Mountain Vistas Specific Plan And Environmental Impact Report

Part IV: Final EIR

October 2005

Figure 1 Location Map

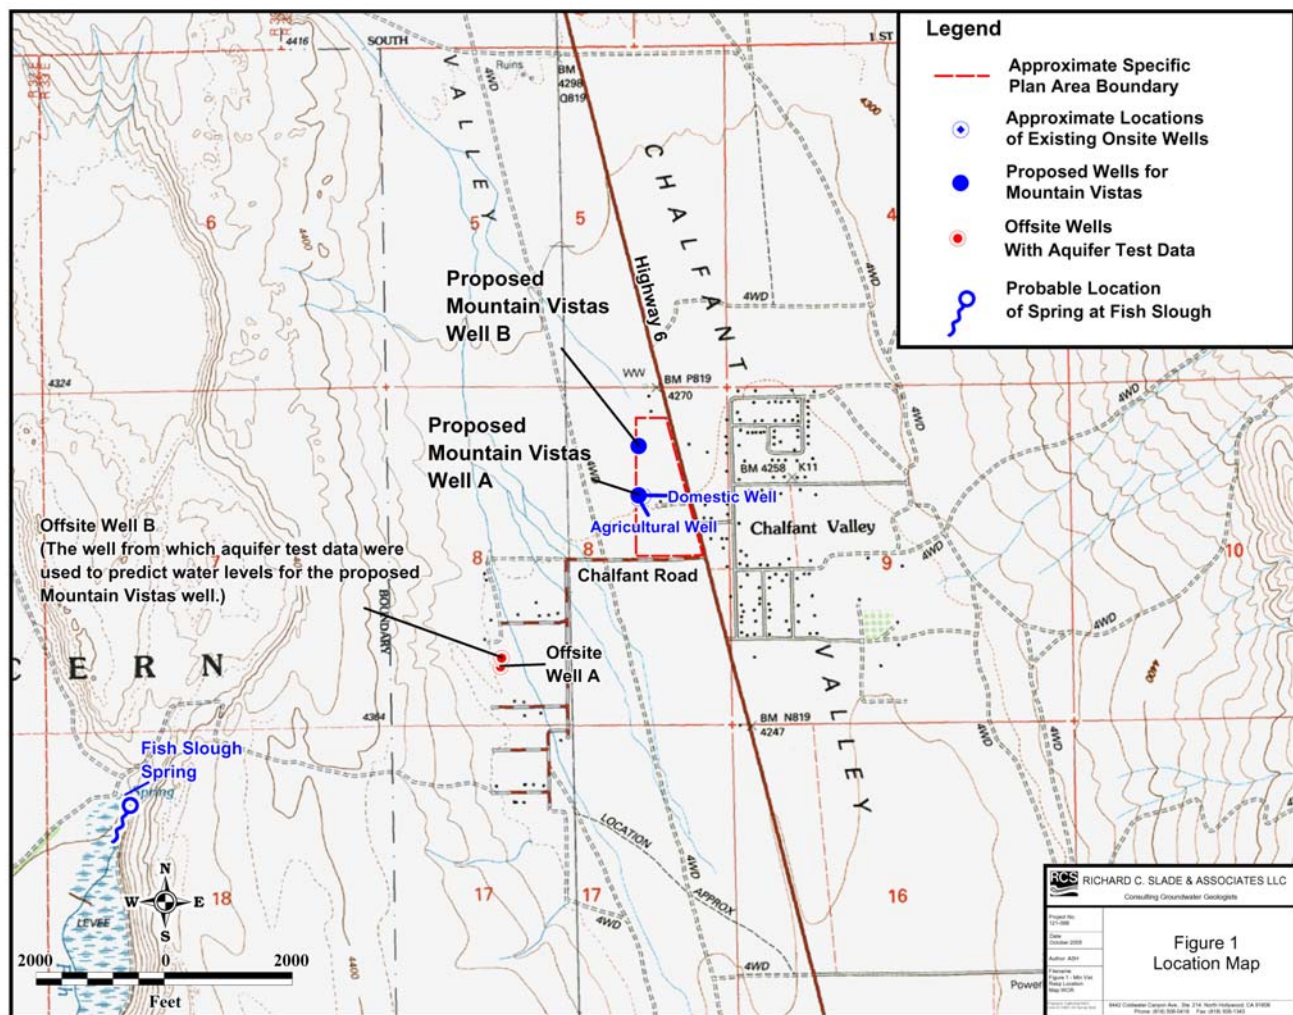
The comment also addresses the potential for water “mining” onsite. The BLM proposes mitigation to assess the maximum safe yield of groundwater pumping and suggests that the maximum safe yield be made a condition for project approval.

- Figure 1, “Location Map;” this map identifies the boundaries of the subject development, provides the locations of the two older, existing onsite wells (a domestic- and an agricultural-supply well), and illustrates the locations of two nearby but offsite wells that were recently sited, constructed and tested by RCS for that other property. Data from that well testing has been utilized for this project as discussed below.

1. Distance Between Sites – Figure 1 shows that Fish Slough is located 1.7 miles to the southwest of the southwestern-most corner of the subject property boundary. Because the distance between the proposed wells and Fish Slough is great, it is highly unlikely that the proposed pumping of the new onsite wells will have any impact on the spring flows.

Recently, RCS was involved in the siting and design of two new offsite water wells just west of the proposed development (see Figure 1). These wells were designed to produce groundwater at roughly similar rates and volumes as those required for the proposed Mountain Vistas development. The boreholes for both of these new offsite wells were drilled through the young alluvium and the Bishop tuff and into the underlying older alluvium. Further, the two new offsite wells were provided with casing perforations solely within the older alluvium.

Calculations of theoretical water level drawdowns were made for the following periods of continuous pumping at a constant rate of 100 gpm by proposed Well A at Mountain Vistas (see location on Figure 1): 3 days (this was the pumping duration of the actual aquifer test to which the model was calibrated); 5 days, 14 days, 30 days, 90 days, and 180 days. It should be noted that the theoretical pumping periods in the calculations assume that the well is pumping continuously (i.e., 100% of the time) for those periods, that is, 24 hours per day, every day, for the entire period being considered. Such pumping scenarios will not and should not occur.

Also for the proposed pumping test(s), it appears possible to monitor water levels in one or both of the two existing onsite wells, the domestic well and the agricultural well, as shown on Figure 1. However, no driller's log is available for either of these old wells, and therefore, nothing is currently known about the depths of the well casing, or the perforated intervals that exist in the wells. Certain down-well work can be conducted, however, to mitigate these problems in an effort to use one or possibly even both of these wells as additional water level monitoring sites during the proposed pumping test(s). Thus, a video log survey can be performed to document the depths of these older wells and their perforated intervals prior to conducting the pumping test(s). Pressure transducers can readily be installed in these existing onsite wells to monitor water levels during the test(s). Analyses of the aquifer test data will then be performed to determine key aquifer characteristics at the site and to compare to the results of the November 2004 testing by RCS at the property to the west.

Figure 2 Geology Map

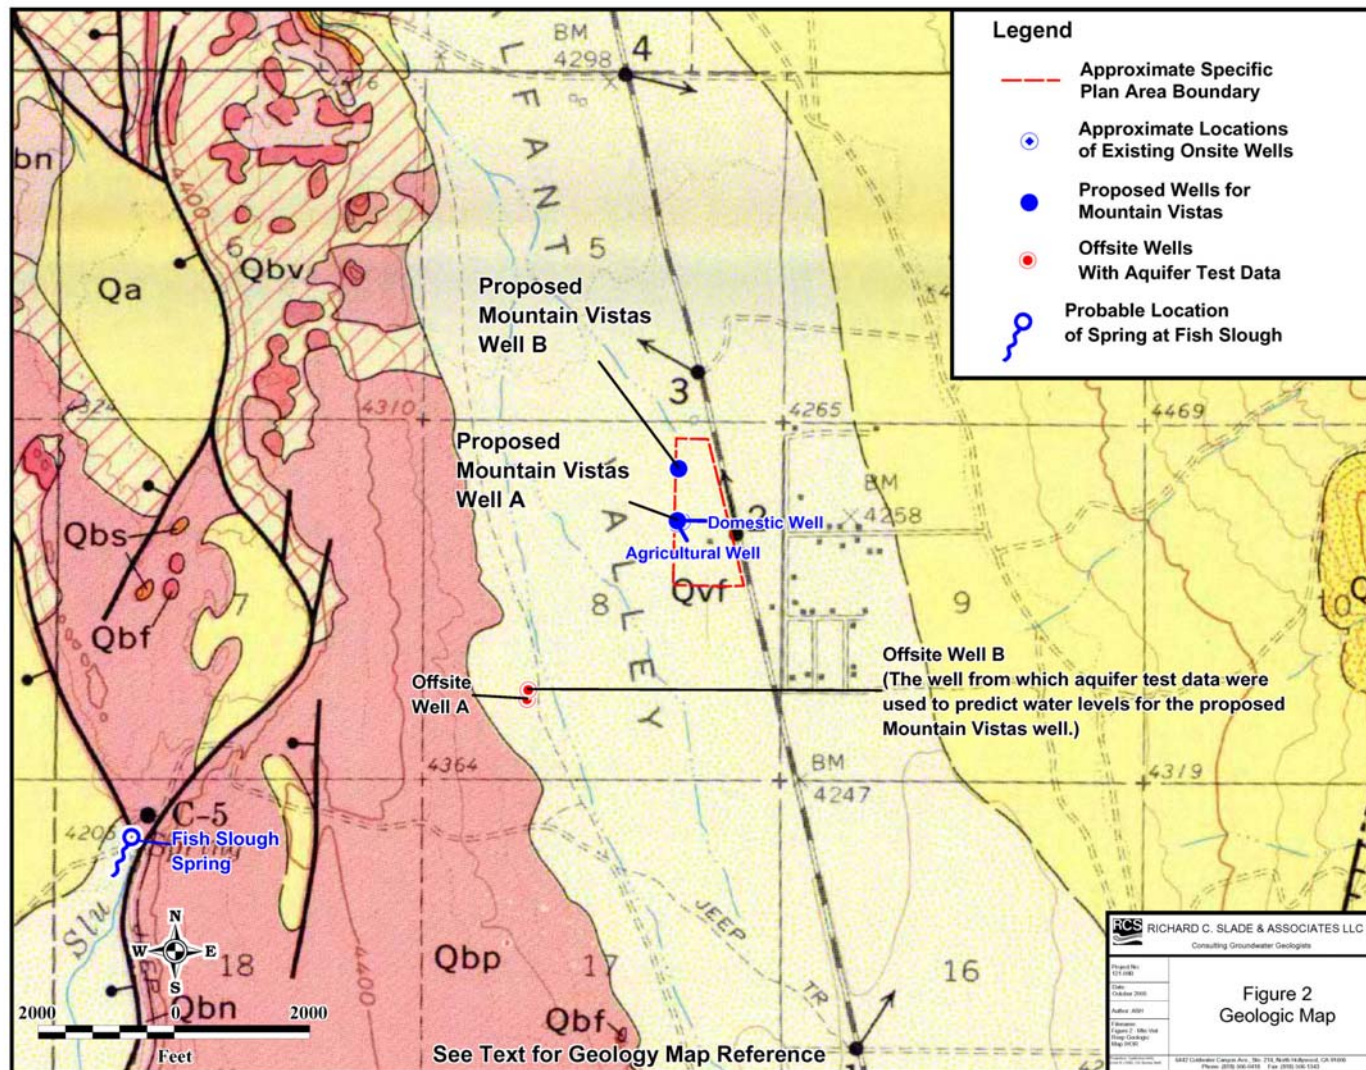
Comment 1c: The comment provides information on the relationship between groundwater in the area and Fish Slough and concludes that:

- Figure 2, “Geology Map;” this map has been adapted from regional geologic field mapping by D.F. Crowder and M.F. Sheridan (1972 USGS publication titled, “Geologic Map of the White Mountain Peak Quadrangle, Mono County, CA). Figure 2 illustrates geologic conditions at ground surface throughout Chalfant Valley and areas to the west, including geologic conditions at/near Fish Slough. The boundaries of the proposed Mountain Vistas project (Specific Plan Area) are shown on the map for reference.

Differences in Geology – As shown on Figure 2, geological formations, from youngest to oldest, that are considered to underlie the subject property, include: alluvium, comprised of silt, sand and gravel; the Bishop tuff (it is possible, but unknown if the Bishop tuff would be encountered when drilling a well at the proposed development); and older alluvium, that underlies the Bishop tuff, and may

More specifically, and based on Figure 2, the spring(s) at Fish Slough originate solely within the Bishop tuff, a solidified volcanic ash-type type rock. Also, the geologic map shows several faults in the area of the spring(s). In fact, the spring(s) appear to originate roughly at the intersection of two mapped faults. These faults are part of a larger fault zone which is comprised by numerous faults (mapped by others) within the Bishop tuff; as seen on Figure 2 all of these faults trend in a general north-south orientation. Therefore, the spring(s) are fault-controlled and solely within the Bishop tuff; as a result, the springs are fed primarily by groundwater that travels within a fault-fractured portion of the Bishop tuff.
